# DART SERVICE INSTRUCTION

## TO AMEND INSTALLATION INSTRUCTIONS D205-523 REV. F, AND INSTRUCTIONS FOR CONTINUED AIRWORTHINESS ICA-D205-523 REV. 1 OR LATER APPROVED REVISIONS

The Weight and Balance of Installation Instructions D205-523 Rev. F and Instructions for Continued Airworthiness ICA-D205-523 Rev. 1 is amended per Section 3 of this Dart Service Instruction (DSI).

**FIGURE 1: Relocation of the D2224 Rappel Anchor**  
LH Installation Shown, RH Installation Opposite

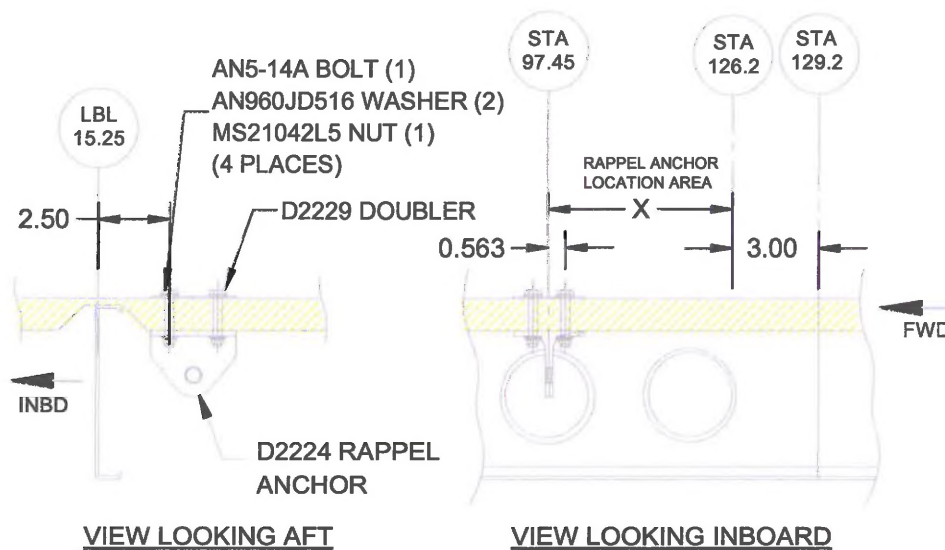
Installation of the D2224 Rappel Anchor per Figure 4 of D205-523 Rev. F may not be compatible with some components on later S/N aircraft. This DSI provides an alternate position for the installation of the D2224 Rappel Anchor.

2.1.1 It is acceptable to install the D2224 Anchor Assembly between STA 97.45 and STA 126.2. as shown in Figure 1 of this DSI instead of the location shown in Figure 4 of D205-523 Rev. F. Keep the innermost attachment hole 2.50" from LBL/RBL 15.25 as outlined in Figure 1 of this DSI. The D2224 Anchor Assembly, D2229 Doublers, and associated hardware are otherwise installed i.a.w. Section 3 of Installation Instructions D205-523.
